**APPLICATION FOR PERMISSION
UNDER SECTION 16 OF
THE TOWN PLANNING ORDINANCE
(CAP. 131)**

For Official Use Only 請勿填寫此欄	Application No. 申請編號	A/I - T07/6
	Date Received 收到日期	2025-06-20

Proposed Public Utility Installation (Poles, Underground Cables and Overhead Cables) and Associated Excavation of Land at Government Land in D.D. 302L and D.D. 313L, Tai O, Lantau

No.	Comments from District Planning Officer/Sai Kung and Islands, Planning Department as at <u>18/7/2025</u> : <u>Contact Person: Ms. YEUNG Yat-ching, Dates Tel.: 2158 6219</u>	Responses

LEGEND :

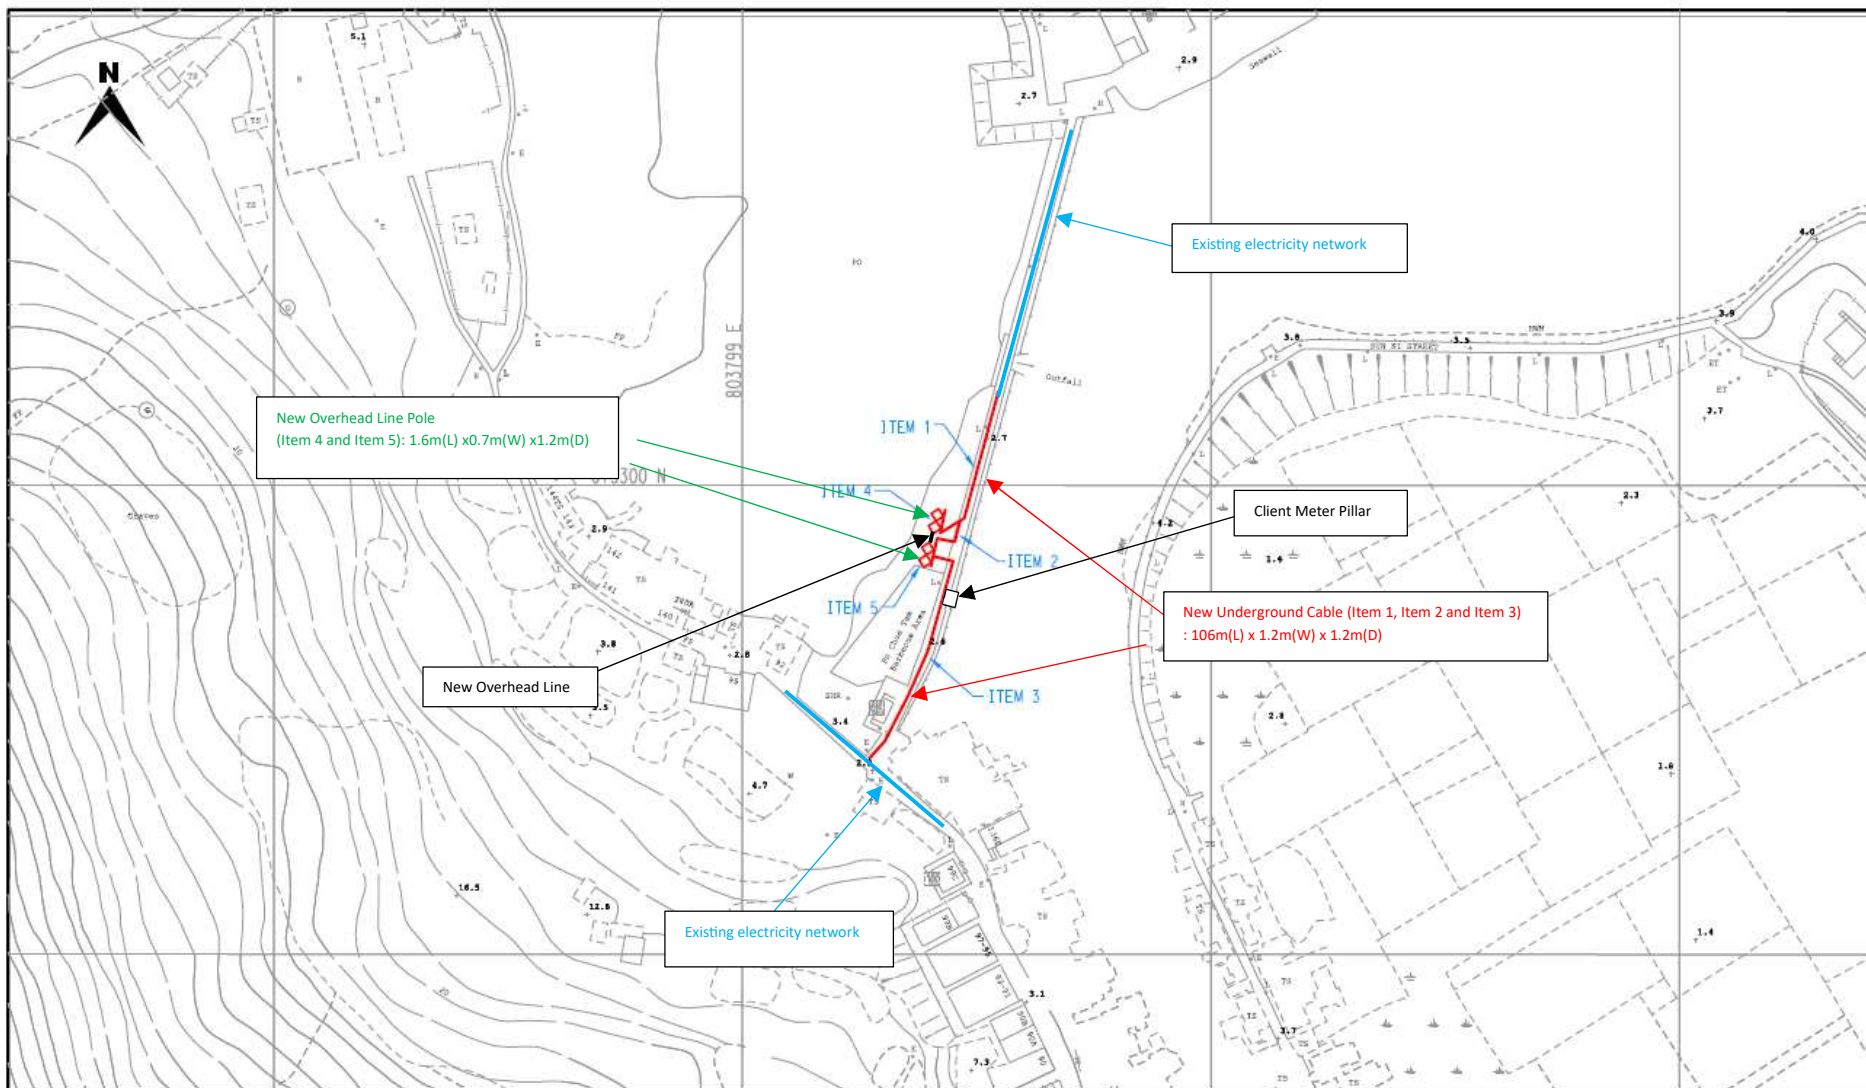
(i)	Please clarify if the proposed installation is to support normal operation for improvement works at Po Chue Tam Footbridge Project (i.e. support the construction stage of the footbridge), or support normal operation of Po Chue Tam Footbridge Project (i.e. support both the construction stage and operation stage after the completion of the footbridge);	The proposed installation is to support normal operation of Po Chue Tam Footbridge Project (i.e. support both the construction stage and operation stage after the completion of the footbridge).
(ii)	In relation to the above, please advise the functions/uses requiring the electricity provision in construction stage and/or operation stage of the footbridge;	The electricity provision is for the power supply to the lighting system and the moveable component of the Po Chue Tam footbridge in which the mid span of the footbridge can be rotated and opened during operation stage. Besides, the electricity provision is for power supply to perform tests related to the testing and commissioning of the lighting system and the movable part of the footbridge during the construction stage of the project.

(iii)	In view of the nature of the footbridge as a Government project, the Applicant should provide letter of proof/consent issued by the Project Proponent in support of the application;	Please find attached reply slip for the condition letters endorsed by the project proponents (CEDD) regarding the application of electricity provision for your information.
(iv)	The planning intention of the subject “Conservation Area” (“CA”) zone is to “protect and retain the existing natural landscape, ecological or topographical features of the area for conservation, educational and research purposes and to separate sensitive natural environment such as Country Park from the adverse effects of development. There is a general presumption against development in this zone. In general, only developments that are needed to support the conservation of the existing natural landscape or scenic quality of the area or are essential infrastructure projects with overriding public interest may be permitted”. The applicant should elaborate how the application is needed to support the conservation of the existing natural landscape or scenic quality of the area OR is an essential infrastructure project with overriding public interest.	The purpose of the planning application is for the public utility installation works for electricity provision to the operation of the proposed Po Chue Tam footbridge, which is being constructed under Civil Engineering and Development Department (CEDD)’s Contract No. IS/2022/01 Improvement Works at Tai O – Phase 2, Stage 2 (The Project). The Project is an essential infrastructure project with overriding public interest. The proposed Po Chue Tam footbridge to be constructed under the Project enhances the connectivity of the Tai O riversides particularly between Sun Ki Street and Kat Hing Back Street, which can significantly shorten the walking distance and time and bring convenience to the elderly, pregnant ladies and the disabled. It also serves as an emergency vehicles access, and its mid span can be opened and transform to viewing platforms during traditional Dragon Boat Water Parade, which allows residents and visitors to watch and appreciate the whole process of the parade at a close distance. The application is critical for facilitating the commissioning and operation of the proposed footbridge.

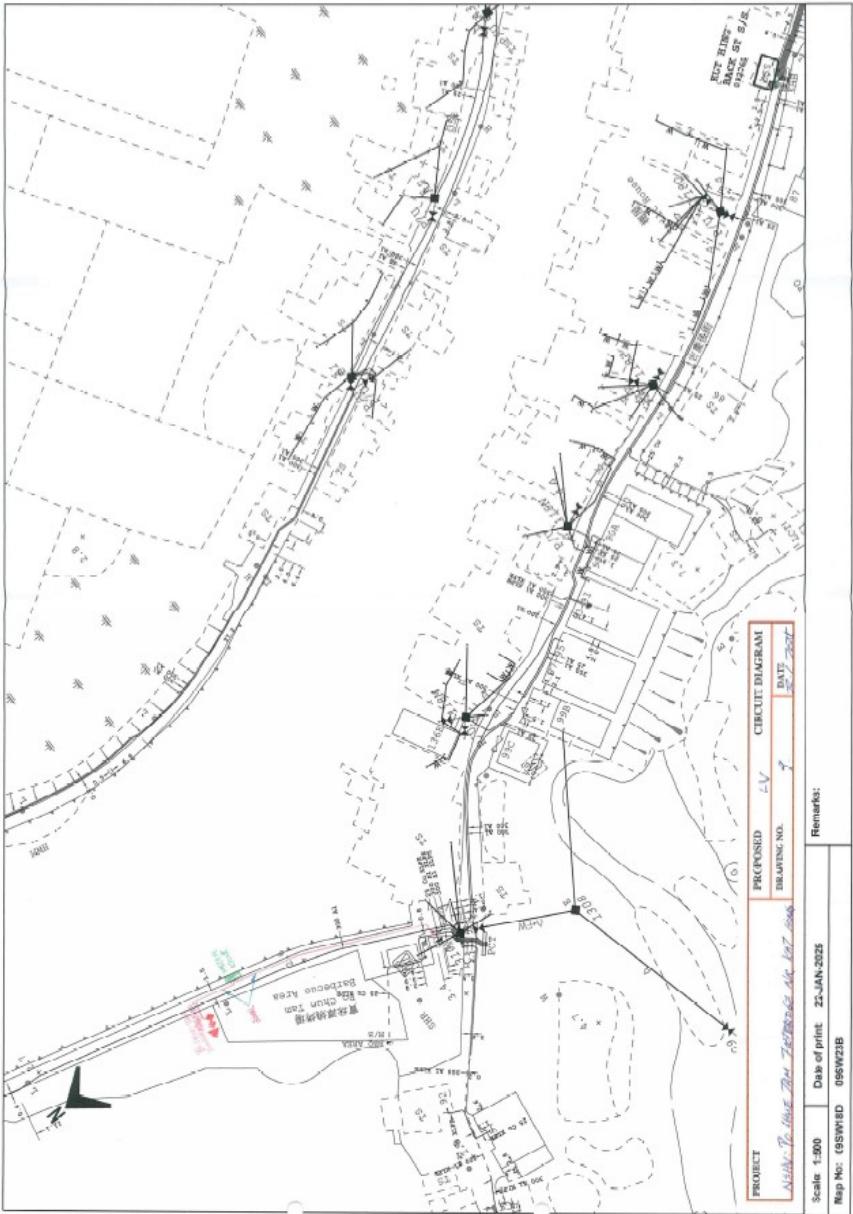
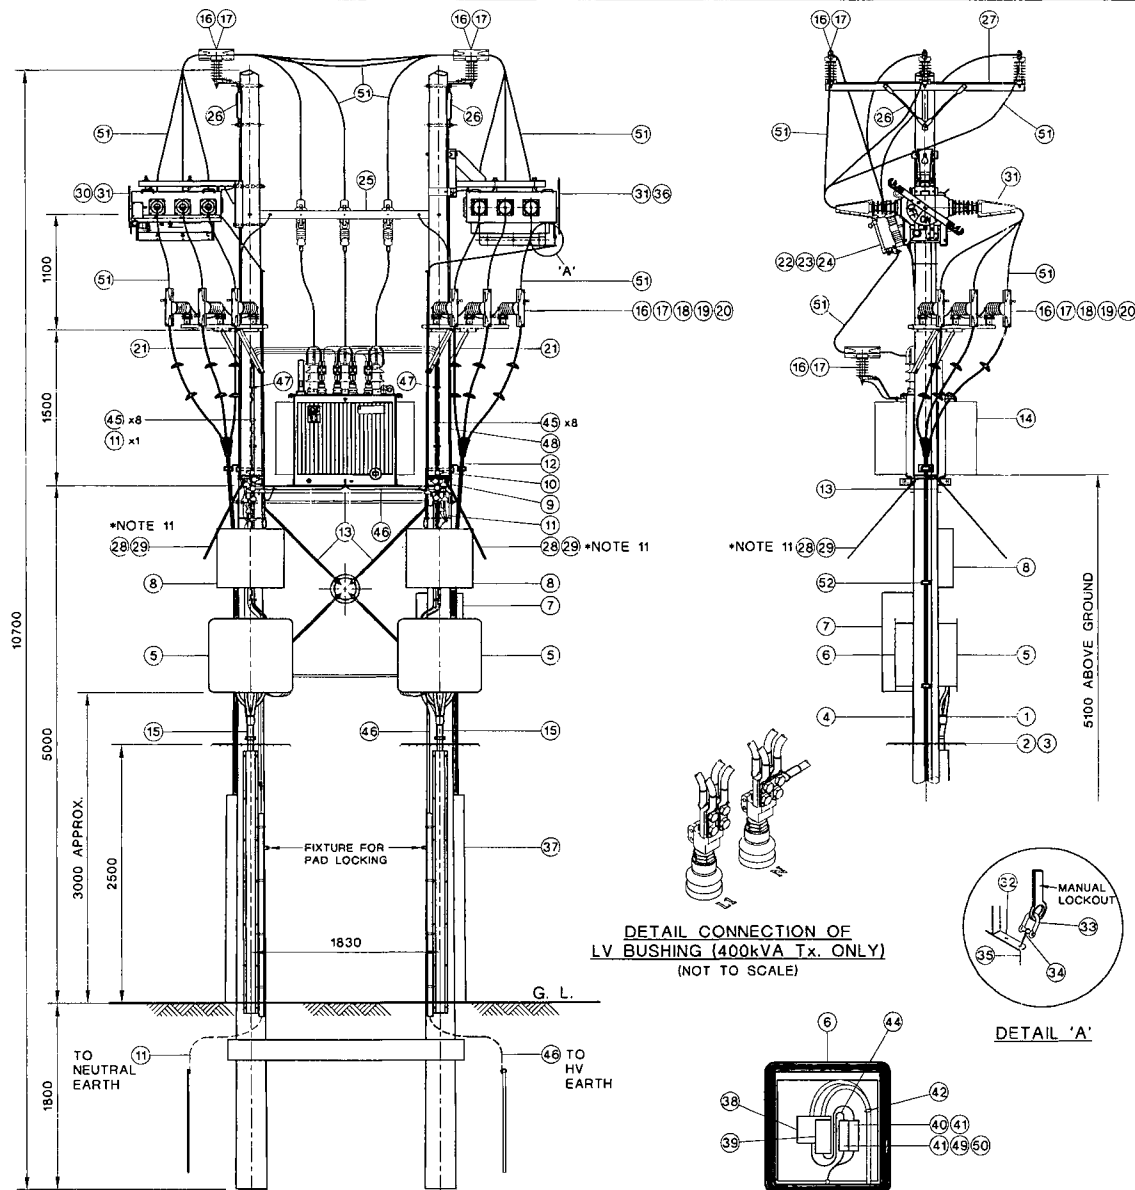
(v)	Please advise the height of four overhead line poles, with inclusion of a section drawing demonstrating the height of poles and excavation depth.	The height of the Pole is 10.5 meters. 
------------	--	---
